**BART Warm Springs Extension Project**

**Final SEIR Addendum**

**Photovoltaic Panels**

**October 17, 2012**

Figure E: Photos of typical photovoltaic system (BART Richmond Shop rooftop, 2012)

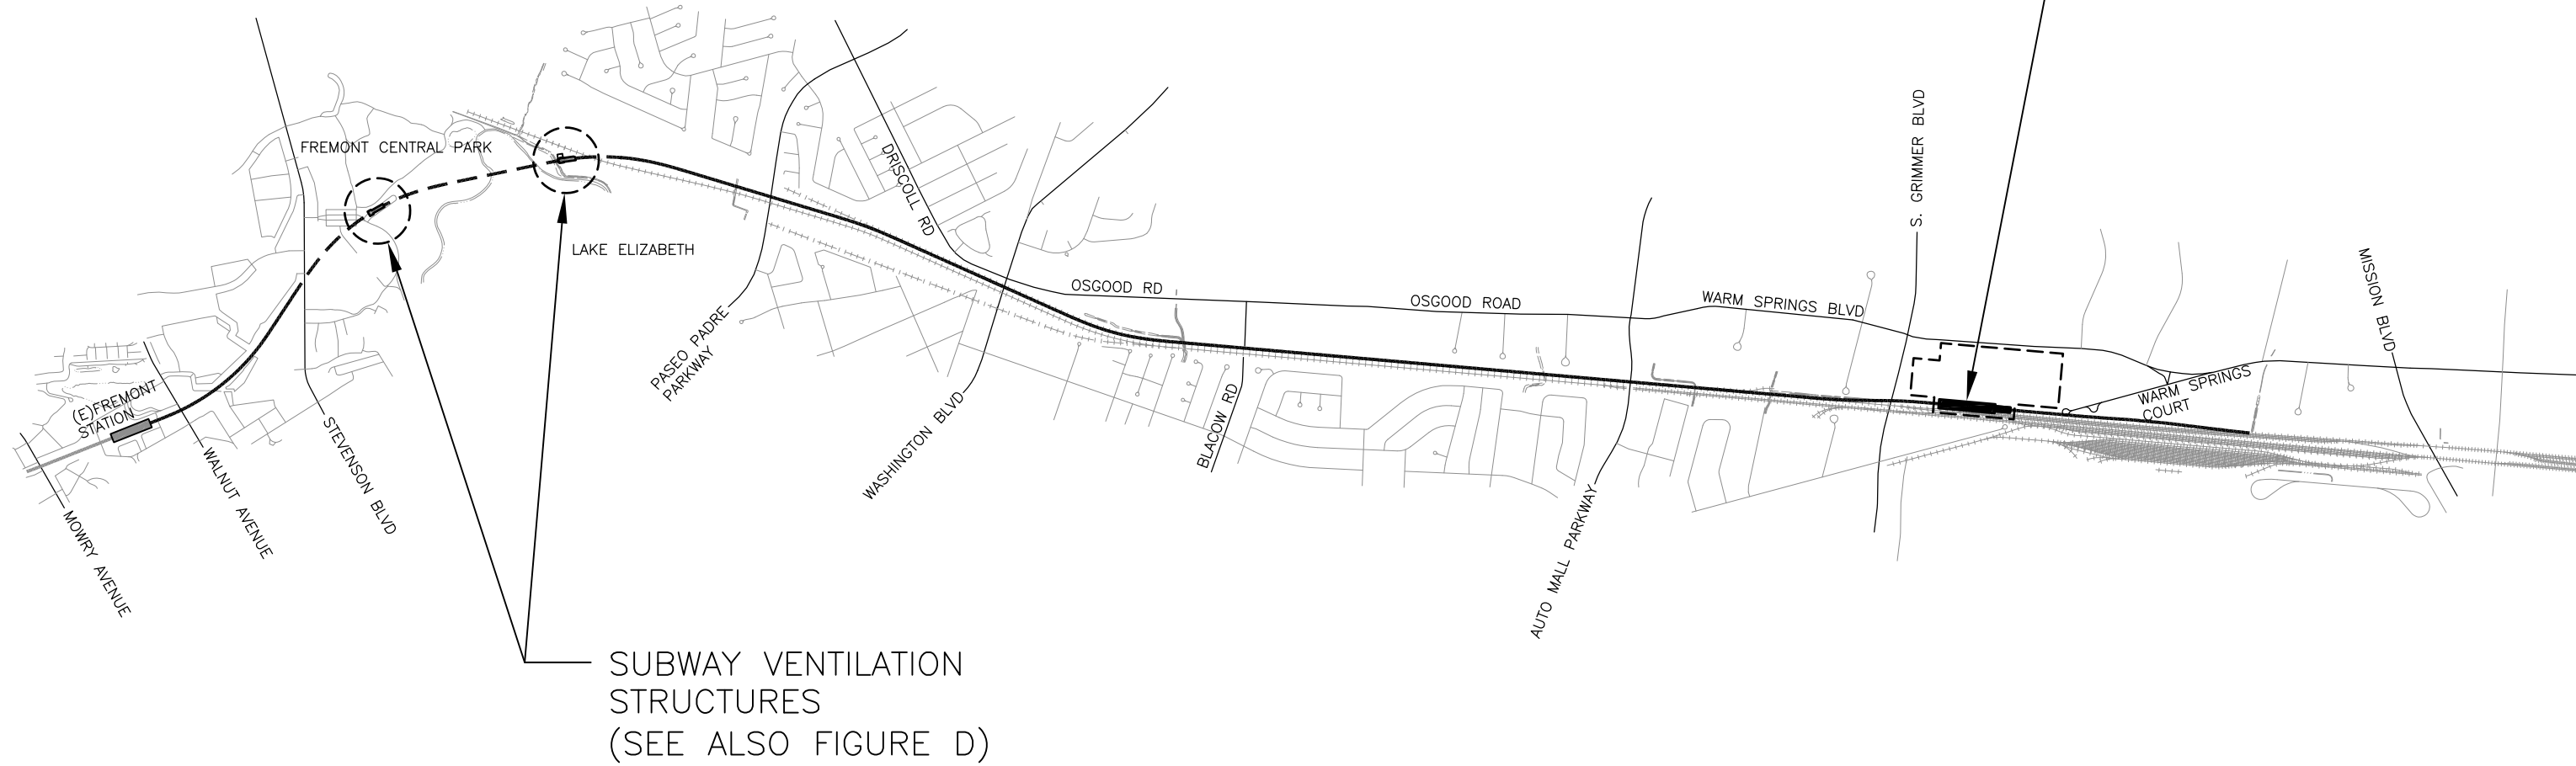
Two subway ventilation structures for the WSX Project are currently being constructed in Fremont Central Park; one is near the sports field complex toward the west side of the park, and the second is east of Lake Elizabeth closer to the former railroad alignments. The subway ventilation structures are large, approximately 242 feet long (including enclosed parking area), 49 feet wide, and 12 feet high. The proposed PV panels would be placed on the rooftop of each ventilation structure. The modular panels would be placed on metal frames sloped to provide maximize exposure to the sun. The PV panels themselves will be dark colored and non-reflective. The mounting frames for the panels are usually aluminum or a similar unpainted metal, which tends to oxidize and lose any sheen and reflectivity over time. The panel frames typically stand about 3 feet high. The PV panels would be within the rooftop parapet wall, but may extend slightly above the 2-foot high parapet wall. Figure E presents photos of panels similar to those being considered for the subway ventilation structures.

Views of the western ventilation structure are primarily from the active sports fields and parking areas closest to it. Views of the lower 2 feet+/- of the panels would be blocked by the rooftop parapet. The upper portion of the panels would be visible to park patrons; however, given the large size of the subway ventilation structures, the panels would be a negligible visual addition to the structures and would not be incompatible with the structure or the surrounding park area. The panels are not tall enough to block views of the surrounding hills and would not generate any light. The low angle of the panels (20 to 40 degrees to horizontal) and the generally non-reflective material would minimize the potential for glare. Therefore, no additional visual impacts are anticipated.

**FIGURE A  
WARM SPRINGS EXTENSION  
PROPOSED PV LOCATION PLAN**

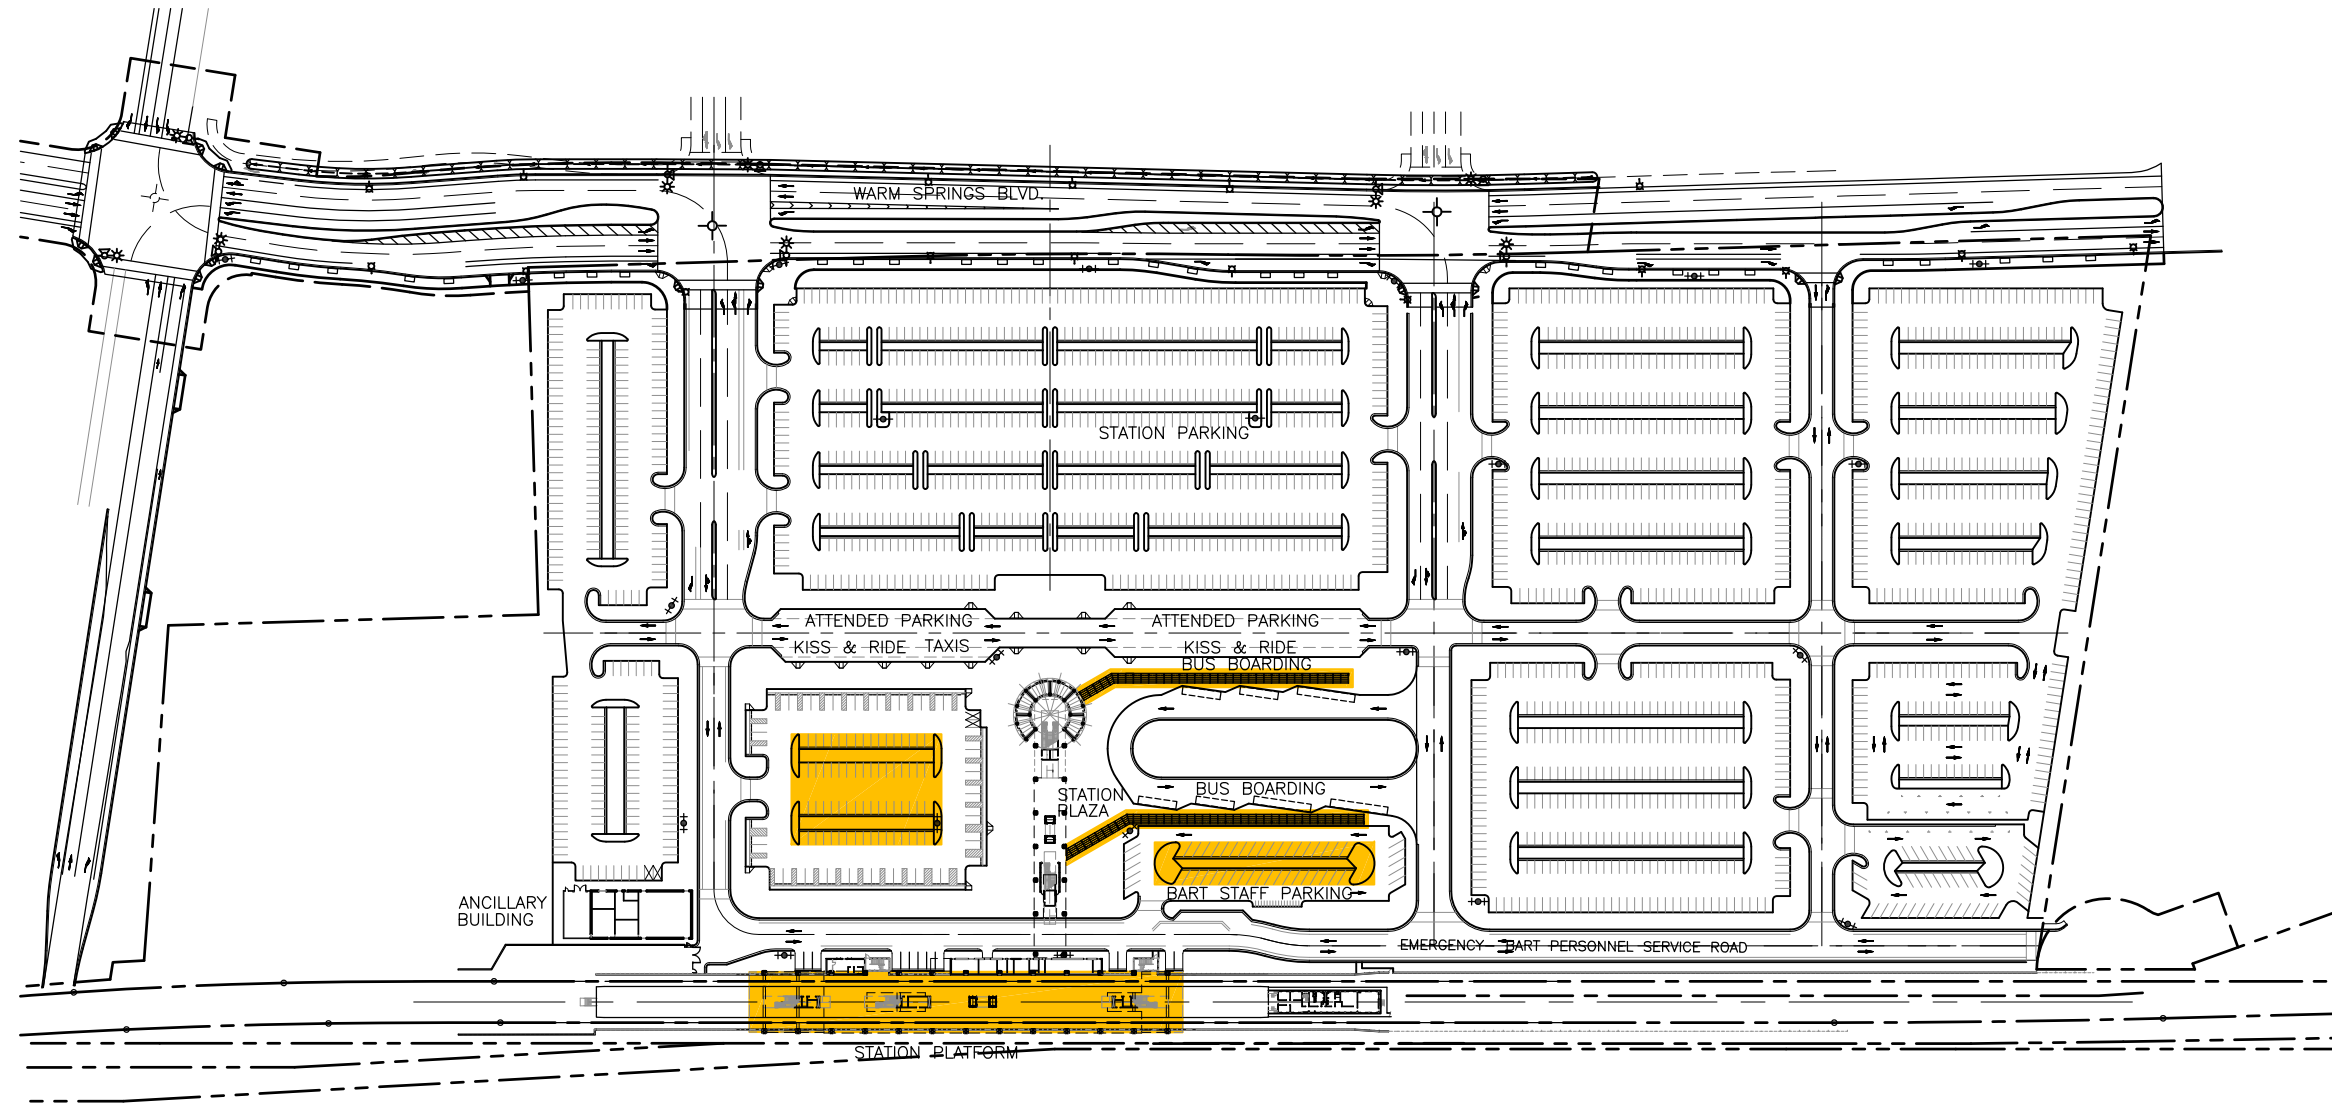
the 38 BART staff and 68 patron parking spaces. The station concourse and bus boarding canopy roof structures are already included in the project, and PV panels would lie flat on those rooftops. In addition, new purpose-built canopies would be constructed over the BART staff parking and patron parking spaces. The purpose-built canopy structures would be sloped to optimize exposure to the sun and maximize generating capacity. The canopy structures would be approximately 16 feet high at the highest point and slope down to a minimum of 10 feet. Power generated by PV panels at the station is expected to be approximately 0.62 MW.<sup>3</sup> The energy generated by the PV systems is expected to serve all the daytime electrical power needs of the station. At times the generation will exceed the station load, and the excess will be fed back into the local electrical grid as it is generated. Figure B illustrates the location of the PV panels at the Warm Springs/South Fremont Station, and Figure C provides a simulation of the station with canopies and panels installed.
